ENCLOSURE 4
PROPOSED CHANGES
MARKED UP PAGES FOR PROPOSED CHANGES TO
APPENDIX A TECHNICAL SPECIFICATIONS OF
FACTORY OPERATING LICENSES
DPR-39 AND DPR-48
FOR LICENSE AMENDMENT REQUEST NO. 92-03

3.3.2 PRESSURIZATION AND SYSTEM INTEGRITY

TYPED PAGES FOR PROPOSED CHANGES TO
APPENDIX A TECHNICAL SPECIFICATIONS OF
FACILITY OPERATING LICENSES
DPR-39 AND DPR-48
FOR LICENSE AMENDMENT REQUEST NO. 92-03

Figure 3.3.2-1

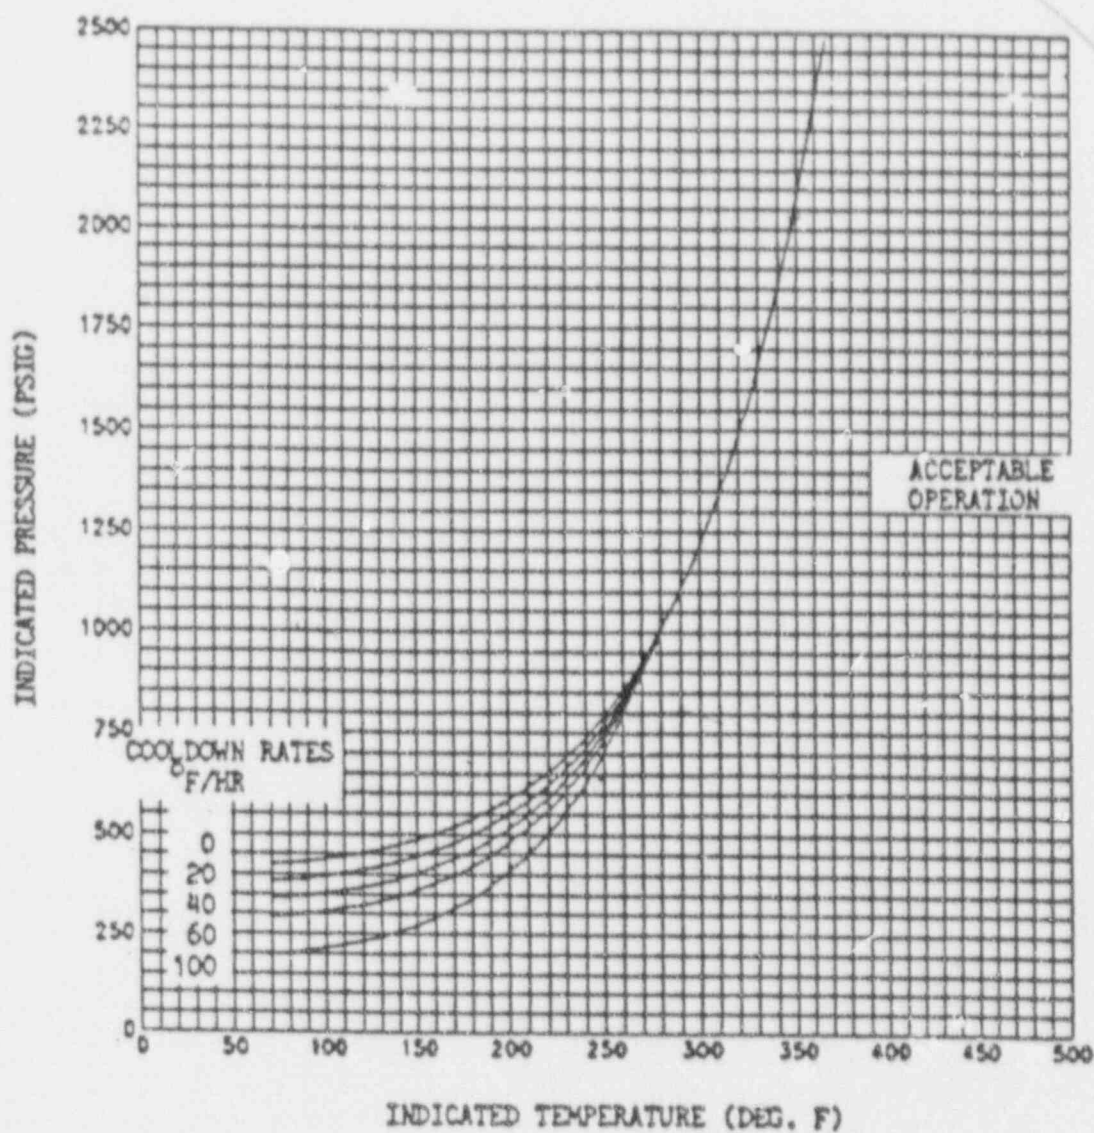
DELETED

Zion 1 and 2 Reactor Coolant System Heatup Limitations applicable for up to 14 EFPY and Heatup Rates up to 20°F/hr and 60°F/hr. Curves contain margins of 10°F and 60 psig for possible instrument errors.

REACTOR COOLANT SYSTEM HEATUP LIMITATIONS

in the PTLR
~~Figures 3.3.2-1 and 3.3.2-2~~ defines limits to assure prevention of non-ductile failure only. For normal operation other inherent plant characteristics, e.g., pump heat addition and pressurizer heater capacity may limit the heatup and cooldown rates that can be achieved over certain pressure-temperature ranges.

The leak test limit curve shown on the heatup curves in the PTLR (~~Fig. 3.3.2-1~~) represent minimum temperature requirements at the leak test pressure specified by ASME Section III and the NRC Standard Review Plan NUREG-0800.

Figure 3.3.2-2

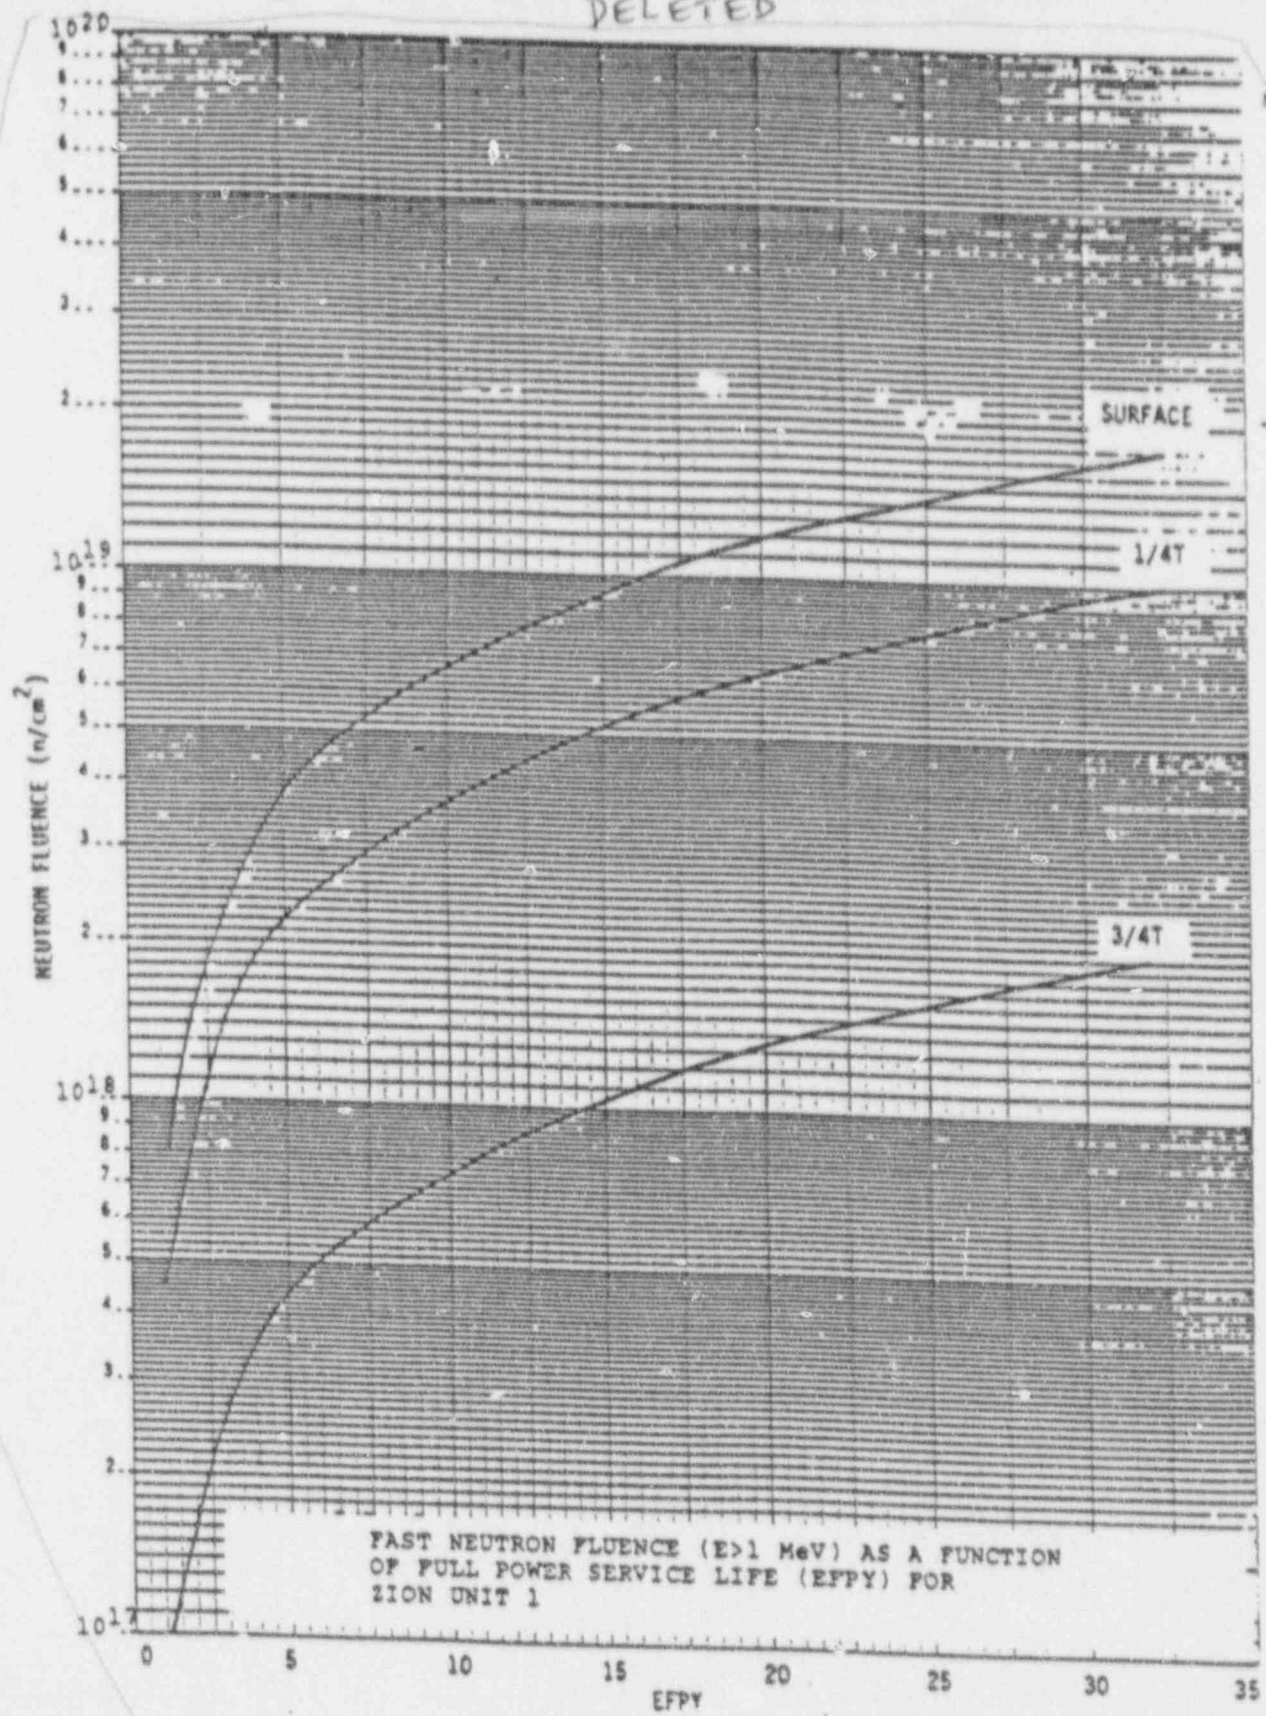
DELETED

Zion 1 and 2 Reactor Coolant System Cooldown Limitations applicable for up to 14 EFPY and Cooldown Rates up to 100°F/HR. Curves contain margins of 10°F and 60 psig for possible instrument errors.

REACTOR COOLANT SYSTEM COOLDOWN LIMITATIONS

Figure 3.3.2-3

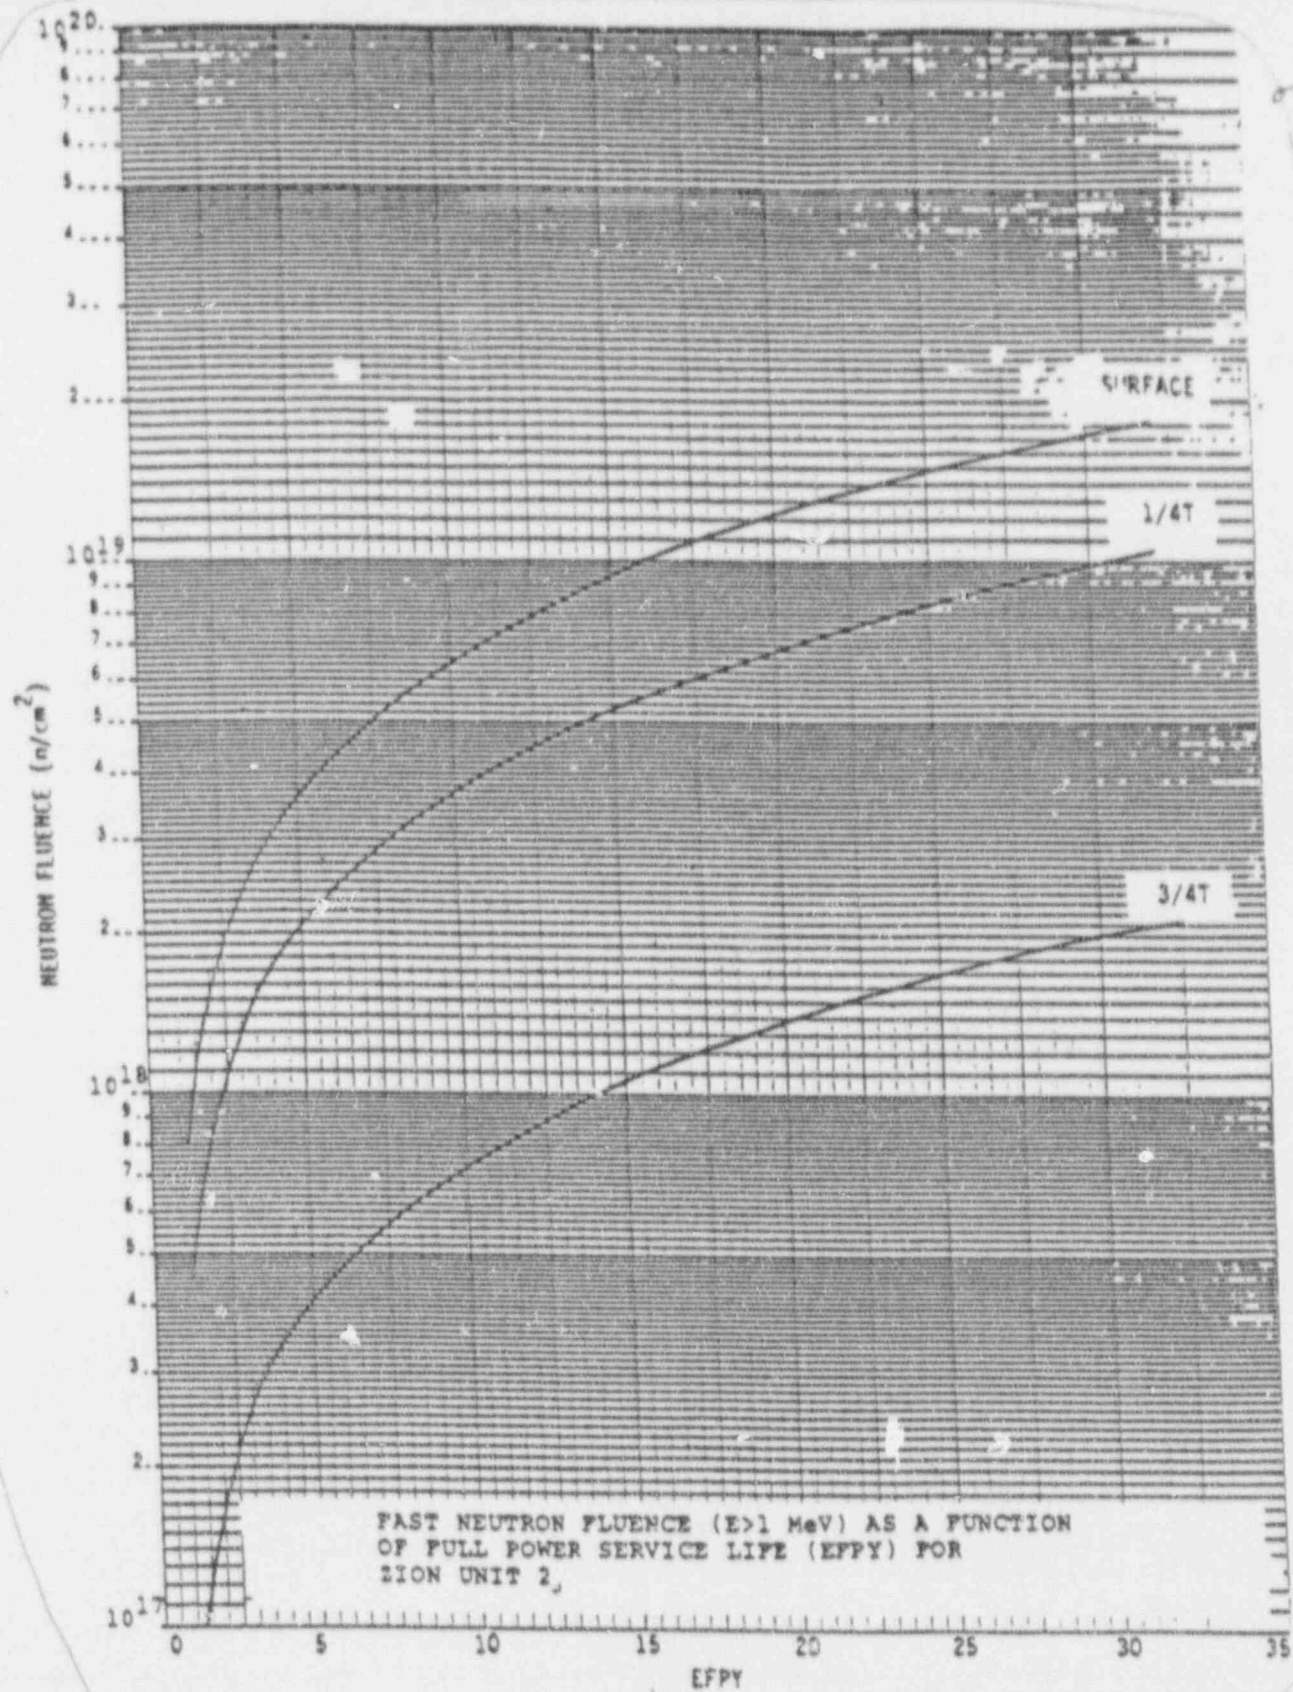
DELETED
